Access Compliance Report

Public Rights-of-Way

Intersection ID: 30136	Main Street: GALESBURG_ST	Cross Street: SIDELL_LN	Location: NW
ADA ID: 8C3306A4895F	Ramp Type: PerpDiag	Initial Pass/Fail: Pass	Overall Compliance: No
Severity Score: 0			
Codes/Mitigation Info/Possible Solution		Field Measurements/Component Compliance

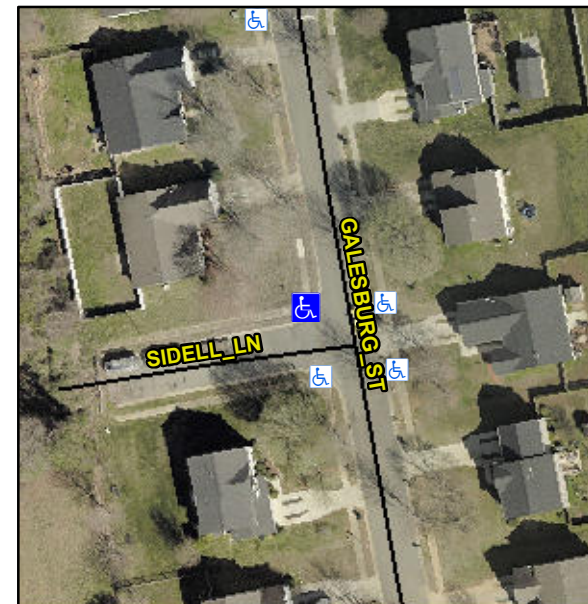
Remove & Replace Curb Ramp With Two New Directional Ramps or Equivalent.

R304.2.1, R304.2.2-Perp, R304.3.2-Para, R305.2
